BEFORE THE PLANNING COMISSION OF THE CITY OF SALEM

**IN THE MATTER OF APROVAL OF) ORDER NO. SUB-ADJ21-05
CONSOLIDATED TENTATIVE)
SUBDIVISION AND CLASS 2) TENTATIVE SUBDIVISION AND
ADJUSTMENT CASE NO. SUB-) CLASS 2 ADJUSTMENT CASE
ADJ21-05 FOR PROPERTY) NO. 21-05
LOCATED AT 2230 DOAKS FERRY)
ROAD NW)**

Case Manager: Olivia Dias, Current Planning Manager

**LOT GRADING &
TREE CONSERVATION
PLAN**

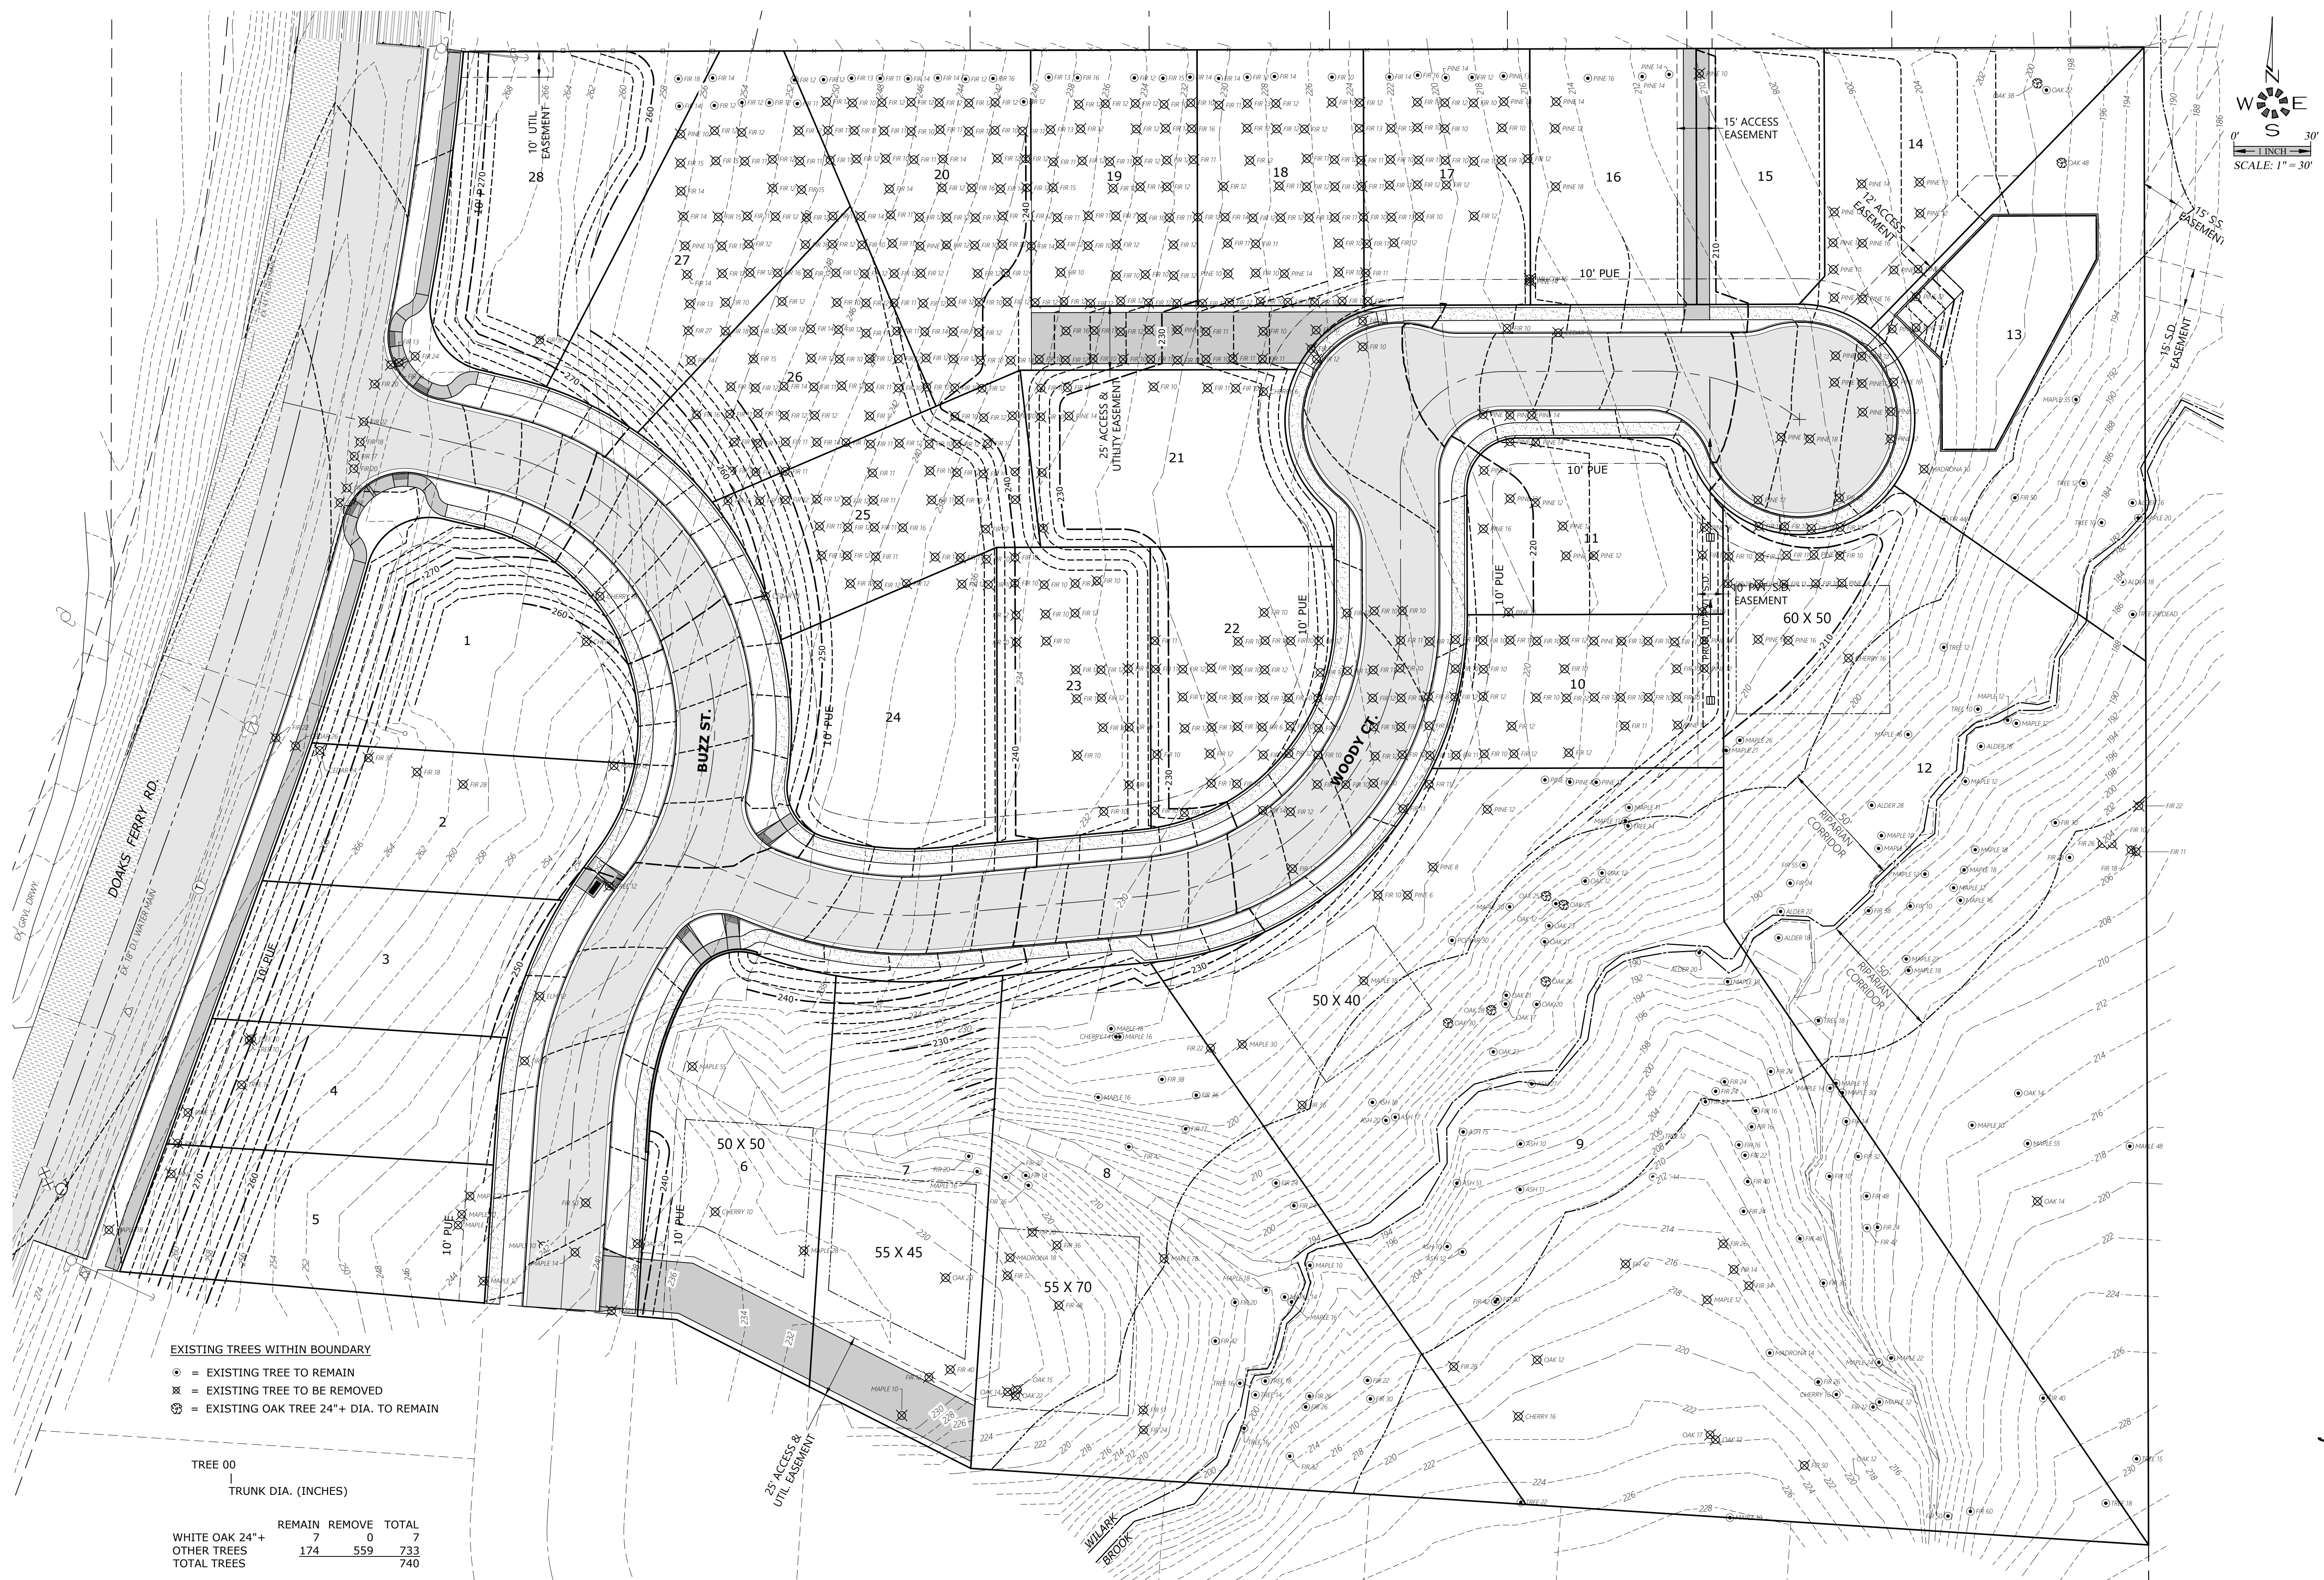
Appellant’s contend the topographic features depicted on Applicants lot grading and tree preservation plan are waterways which must be depicted on the application, together with their associated riparian corridors. The two topographic depressions have not been designated as a waterway by the Director as required by SRC 808.005, are not reflected as a drainage way on the most recent USGS maps, and are not reflected on any available on-line source reviewed as a waterway. Riparian Corridors are defined in SRC 111.001 as “area adjacent to a waterway”. As the

The application materials contain all the required information. Applicant’s lot grading and tree conservation plan reflects the topographic features on the site, and depicts Wilark Brook and the riparian corridor along Wilark Brook, as well as topographic features to the west and east of Wilark Brook, which direct any surface water on the site into low areas, ultimately passing it to Wilark Brook. SRC 808.005 defines a waterway as “any river, perennial stream or creek within the city as designated by the Director.” Only Wilark Brook has been designated as a waterway. Accordingly, Applicant has depicted the only waterway on the premises, and the topographic information provided by Applicant reflects the topographic features which would direct water to low points and to Wilark Brook. Thus, the application identifies canals, ditches, and waterways on the property indicating as required by SRC 205.030(a)(10).

The above mitigation is for removal of the two Douglas fir trees on Lot 8 indicated for removal in the "Lot Grading and Tree Conservation Plan" only. Any additional tree removal within the riparian corridor shall require a Tree Conservation Plan Adjustment and be review based on submittal and approval of an arborist report.

Figure 1: Image from Salem Keizer Local Wetlands Inventory (1999)

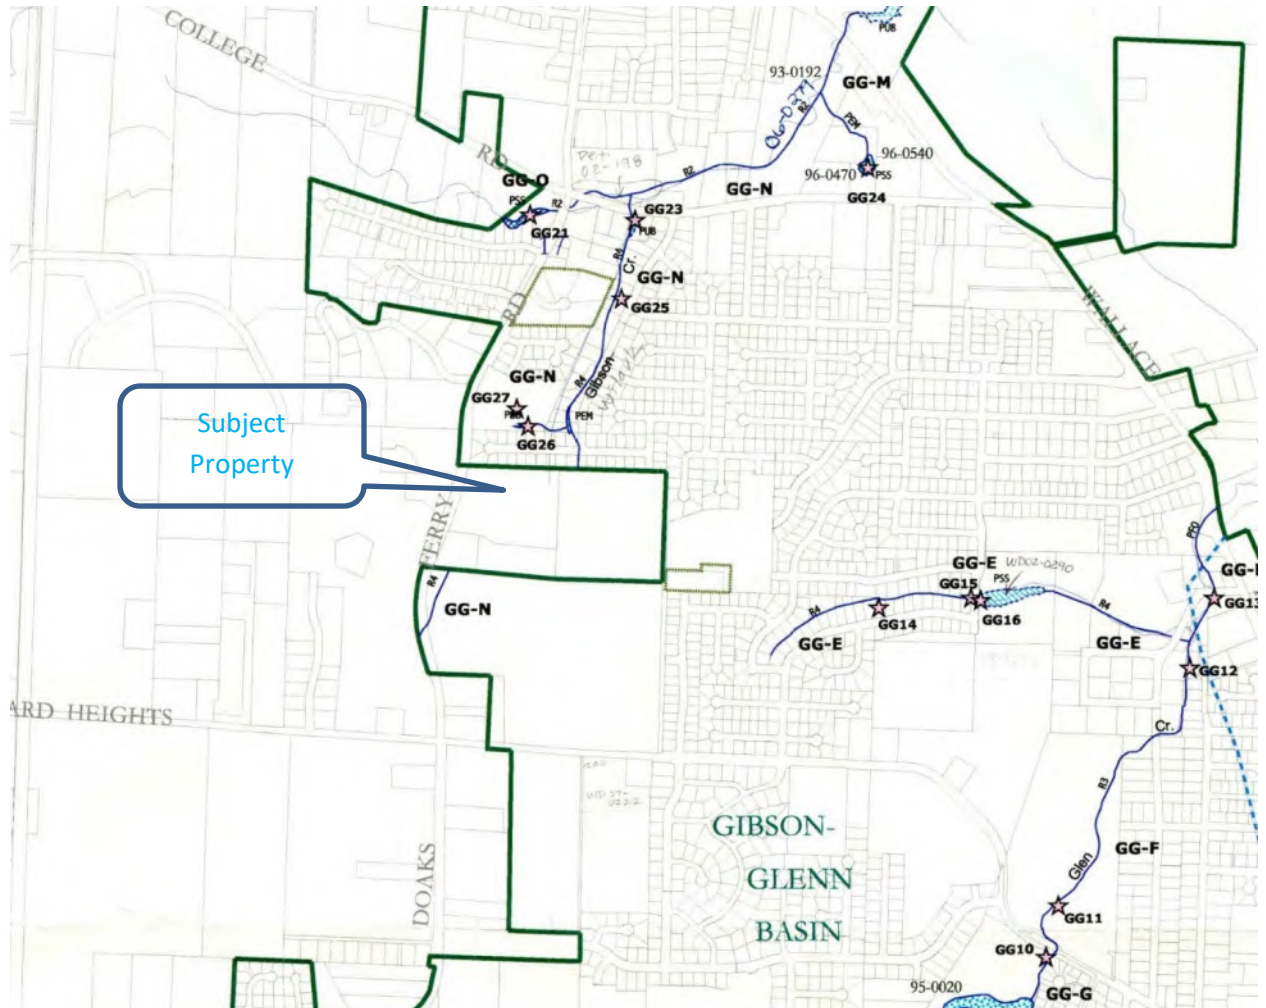
1. The application fails to identify two headwater streams tributary to Wilark Brook as required by SRC 205.030 (a) (10) and (11) *to locate waterways* (10) and SRC 250.005 (c) submittal requirements *to locate natural features including creeks*.
2. The application does not include a wetland inventory. The subject property was outside the City as shown on the Salem Keizer Local Wetland Inventory that was conducted in 1999 (Figure 1).

The approval on page 17 erroneously asserts: “The Salem-Keizer Local Wetland Inventory (LWI) does identify wetlands on the subject property.”

This statement is in error since the subject property was not a part of the 1999 Local Wetlands Inventory (Figure 1).

Figure 4: Map showing Tributary A

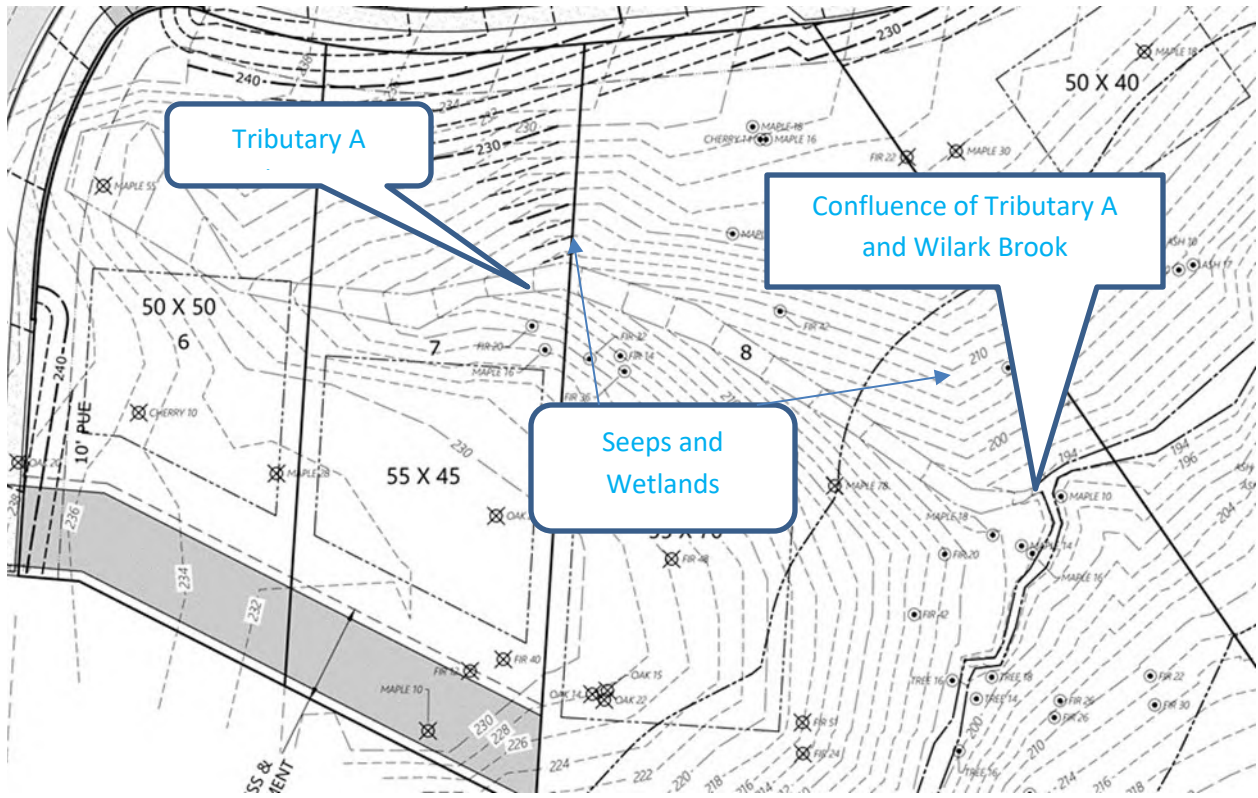
These two existing streams are not identified in the application. The designation of these streams and their 50-foot riparian corridors should be identified under the provisions SRC Chapter 808 and appropriate provisions made for their protection.

As shown in the application, the building envelope of Lot 6 fully occupies the riparian corridor of Tributary Stream A and the NE corner of the envelope extends directly into the stream. The building envelopes of Lot 7 and Lot 8 occupy the riparian corridor of Tributary Stream A and nearly extend into the stream.

Figure 7: Habitat Tree in the Riparian Corridor of Tributary B (photo 6/9/2021)

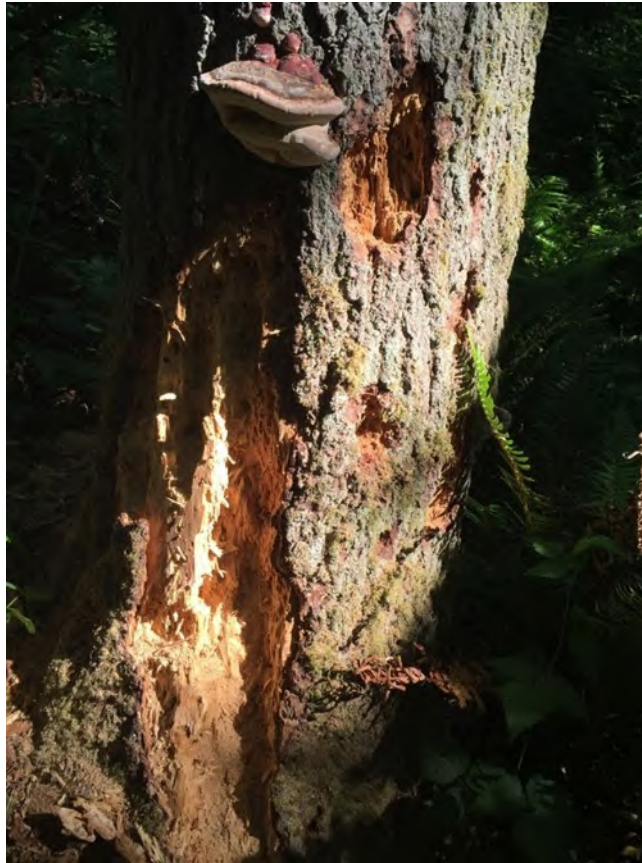
Other wildlife habitat values include the riparian cover to the tributary streams that help to maintain cool water in Wilark Brook and associated wildlife habitat such as the snag (Figure 7) providing habitat for cavity nesting birds and animals.
